ADDENDUM 2 – JOB 8

TO: All prospective bidders on project NHU-1-981(101)111, Job No. 8, scheduled for the October 9, 2015 bid opening.

TO: All prospective bidders on project NHU-1-981(101)111 PCN 20196, Job 8, scheduled for the October 9, 2015 bid opening.

Project: NHU-1-981(101)111 (PCN-20196)

ESTIMATE OF QUANTITIES

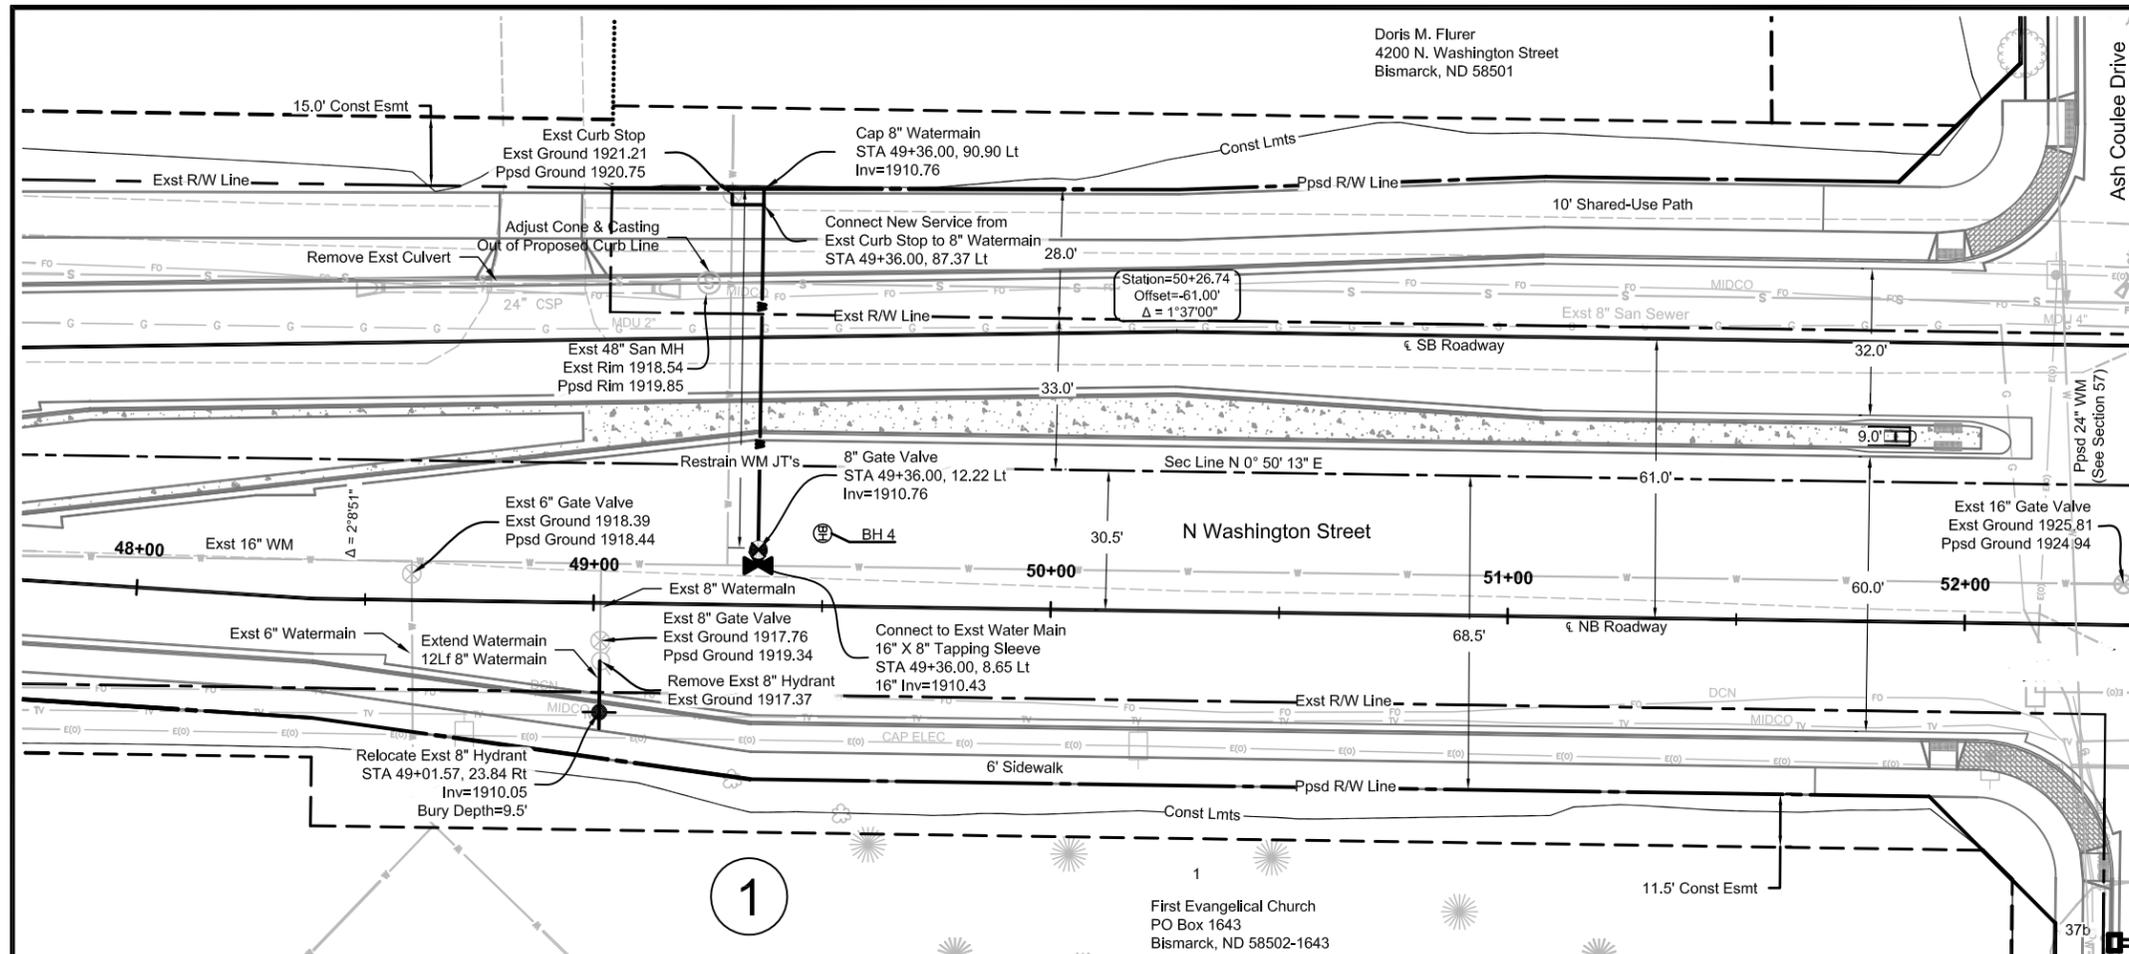
Item 724 0210 FITTINGS-DUCTILE IRON; quantity increased from 1540 to 1585 LBS.
Item 724 0310 GATE VALVE & BOX 8 IN; quantity increased from 1 to 2 EA.

Item 724 0820 WATERMAIN 8IN; quantity increased from 159 to 238 LF.
Item 724 0944 CONNECTION TO EXISTING MAIN; quantity increased from 5 to 6 EA.
Item 724 0960 WATER SERVICE CONNECTION 2IN; 1 EA was added.

724	0427	ADJUST HYDRANT	EA	2	-	-	2
724	0430	REMOVE HYDRANT	EA	1	-	-	1
724	0820	WATERMAIN 8IN	LF	29	-	209	238
724	0855	12IN WATERMAIN	LF	-	-	239	239
724	0858	WATERMAIN 16IN	LF	966	-	132	1,098
724	0870	24IN WATERMAIN	LF	-	-	3,109	3,109
724	0891	WATERMAIN MODIFICATIONS	L SUM	1	-	-	1
724	0944	CONNECTION TO EXISTING MAIN	EA	-	-	6	6
724	0960	WATER SERVICE CONNECTION 2IN	EA	-	-	1	1
724	1020	MEDIAN SPRINKLER SYSTEM	L SUM	1	-	-	1
724	1117	12IN SANITARY SEWER PIPE	LF	-	-	619	619
724	1118	15IN SANITARY SEWER PIPE	LF	-	-	109	109
744	0100	POLYSTYRENE INSULATION BOARD	BD FT	10,928	-	1,536	12,464
748	0140	CURB & GUTTER-TYPE I	LF	34,197	-	-	34,197
750	0111	DECORATIVE PAVED BOULEVARD	SY	175	-	-	175
750	0115	SIDEWALK CONCRETE 4IN	SY	13,558	-	-	13,558
750	0140	SIDEWALK CONCRETE 6IN	SY	577	-	-	577
750	0200	CONCRETE MEDIAN PAVING	SY	3,833	-	-	3,833
750	0210	CONCRETE MEDIAN NOSE PAVING	SY	451	-	-	451
750	1020	DRIVEWAY CONCRETE 8IN	SY	209	-	-	209

STATE	PROJECT NO.	SEC. NO.	SHEET NO.
ND	NHU-1-981(101)111	55	7

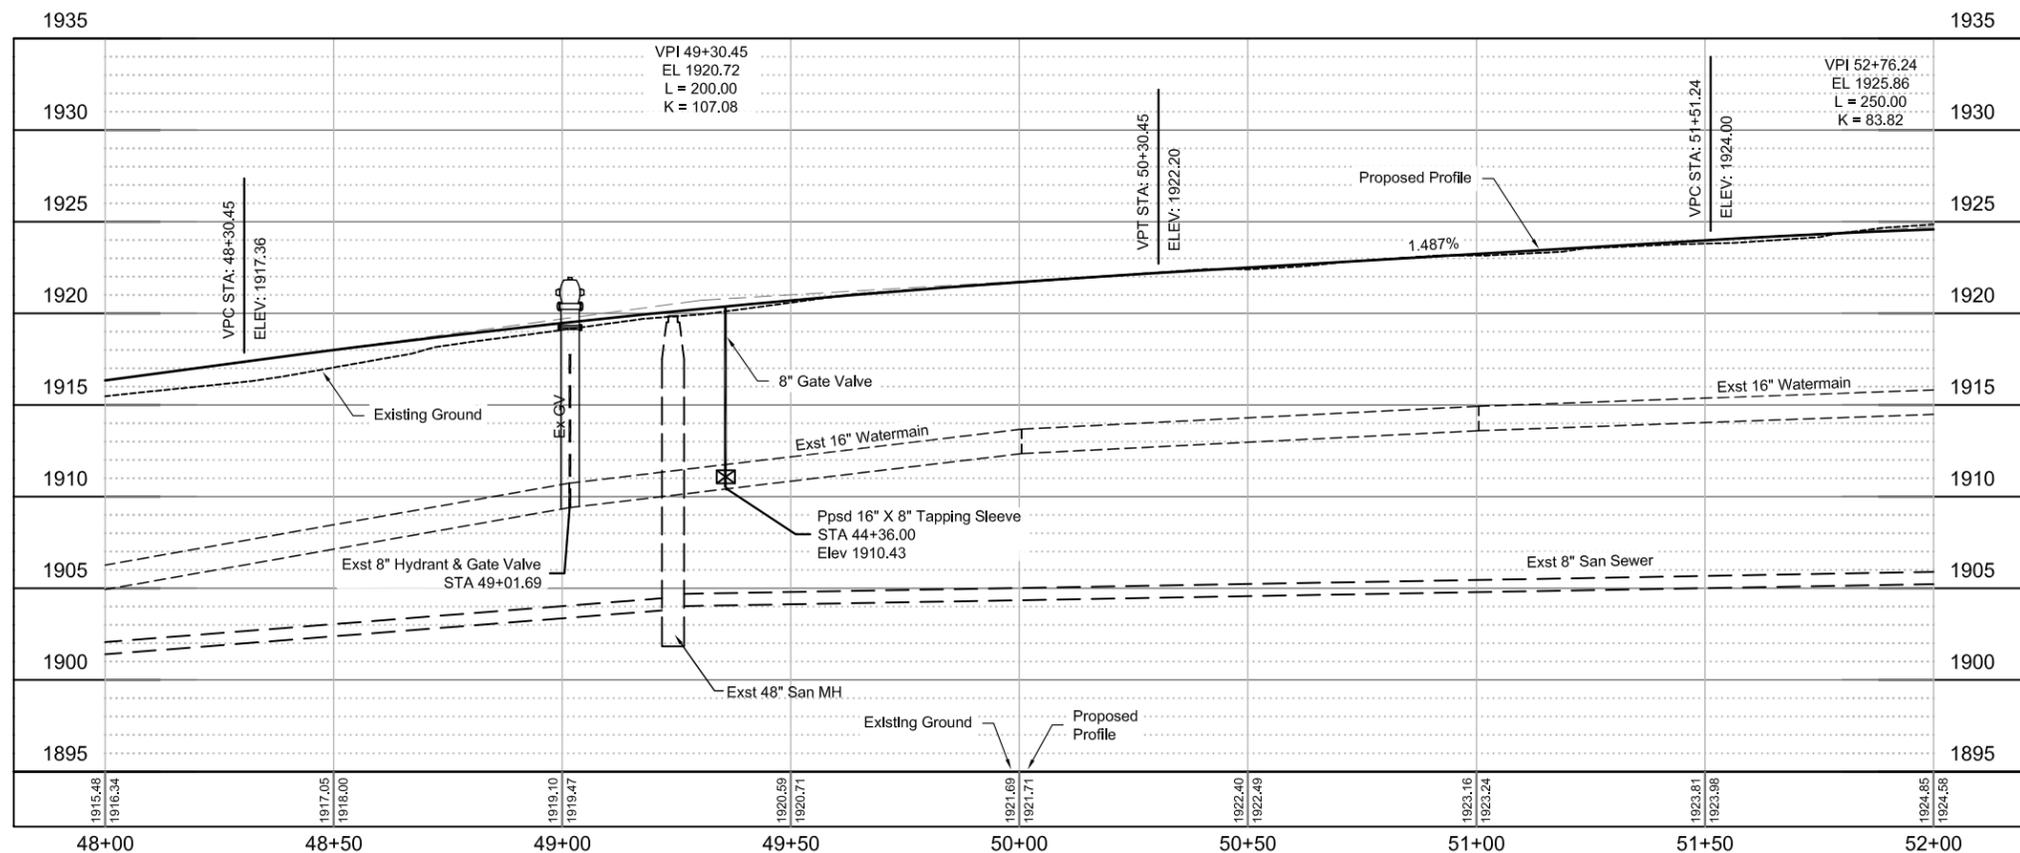
- Section 6 Sheet 7: Revised 724-P14 to include new water main connection at Sta 49+36
- Section 6 Sheet 12: Revised 772-P12 to include communication from City traffic engineer's office to master controller.
- Section 6 Sheet 15: Added 724-P18 for new water main connection at Sta 49+36
Added 770-100 for lighting foundation anchor bolt requirement
- Section 8 Sheet 3: Revised following 100% City Funds bid items:
- 724 0210 Fittings-Ductile Iron; from 675 LBS to 720 LBS
 - 724 0310 Gate Valve & Box 8IN; from 1 EA to 2 EA
 - 724 0820 Watermain 8IN; from 130 LF to 209 LF
 - 724 0944 Connection to Existing Main; from 5 EA to 6 EA
- Added the following 100% City Funds bid item:
- 724 0960 Water Service Connection 2IN; 1 EA
- Section 55 Sheet 7: Added new water main connection at Sta 49+36

MANHOLE REPAIR Sta 49+24, 70' Lt	1 EA
ADJUST UTILITY APPURTENANCE Sta 48+60, 6' Lt (GATE VALVE BOX) Sta 49+01, 8' Rt (GATE VALVE BOX) Sta 49+29, 90' Lt (CURB STOP)	1 EA 1 EA 1 EA
HYDRANT-RELOCATE Sta 49+02	1 EA
WATERMAIN 8IN Sta 49+02, 12' Rt to Sta 49+02, 24' Rt	12 LF
NON-PARTICIPATING FITTINGS-DUCTILE IRON Sta 49+36, 91' Lt (8IN CAP)	45 LBS
GATE VALVE & BOX 8IN Sta 49+36, 12' Lt	1 EA
WATERMAIN 8IN Sta 49+36, 12' Lt to 49+36, 91' Lt	79 LF
WATER SERVICE CONNECTION 2IN Sta 49+36, 88' Lt	1 EA
CONNECTION TO EXISTING MAIN Sta 49+36, 9' Lt	1 EA
